re: Geotechnical Review – Grading and Landscaping Plans
Proposed Residential Development
475 Terry Fox Drive – Ottawa, Ontario

file: PG7418-MEMO.02

- Grading Plan – 475 Terry Fox Drive – Job No. 24103 – Drawing No. C-5, C-6 and C-7, Revision 3 October 28, 2025.

Figure 1 – Recommended Lightweight Fill Location Plan

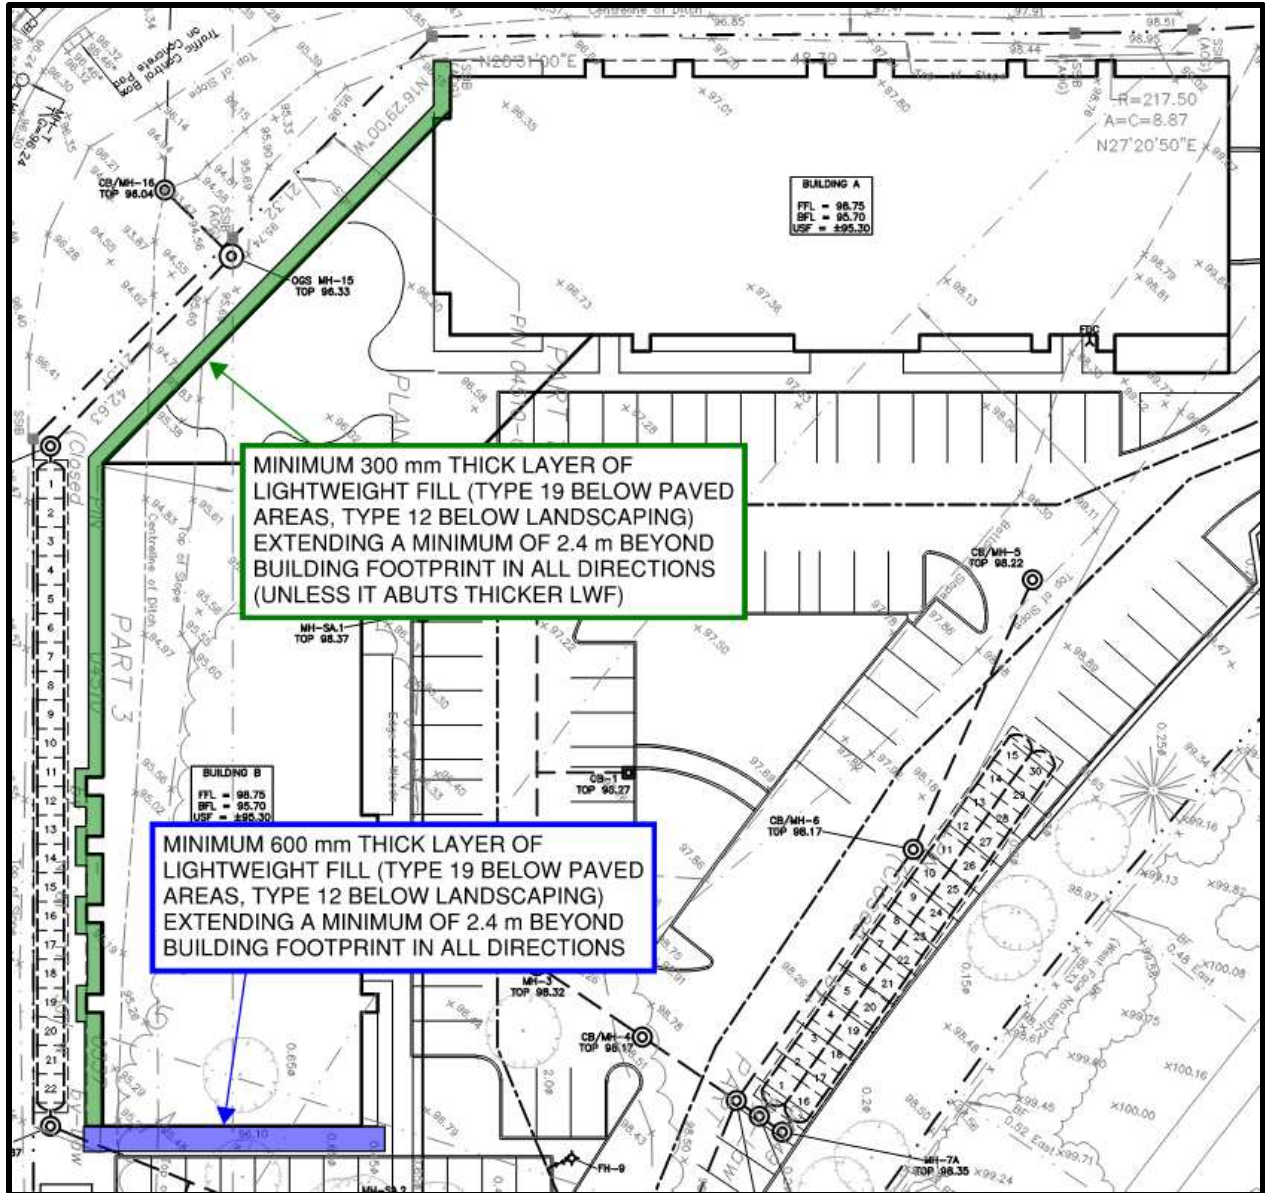
However, some grade raise exceedances were identified in areas surrounding the proposed Building A and Building B. For these areas, lightweight fill is recommended to be placed per the locations identified in Figure 1 below to accommodate the grade raise restriction exceedances and mitigate long-term settlements.

Provided the proposed grading is accommodated using lightweight fill as described in this memorandum, the proposed grading for the proposed development is considered acceptable from a geotechnical perspective.

Lightweight fill (LWF) should consist of EPS (expanded polystyrene) Type 19 and Type 12 geofoam blocks throughout hardscaped (paved or other areas with concrete surface features) and landscaped areas, respectively. The LWF is recommended to be placed a minimum of 500 mm above any perimeter drainage sleeves/pipes provided to the main building structures foundation and the associated open-graded stone layers. The lightweight fill should be placed upon a flat soil surface. Therefore, the soil should be compacted to be relatively smooth and flat prior to installation. Consideration may be given to placing a thin layer of sand or stone dust to attain a relatively smooth/flat surface for placement.

The entire lightweight fill layer footprint is recommended to be covered with a layer of polyethylene (taped at seams) extending between the building footprint and outer edge of the layer and extending below its surface by a minimum of 100 mm at all edges of the lightweight fill layer.

If the lightweight fill will be located in an area of landscaping, a minimum 600 mm of soil cover is recommended to be provided to the lightweight fill layer to promote grass and associated vegetation to establish overtop the lightweight fill.
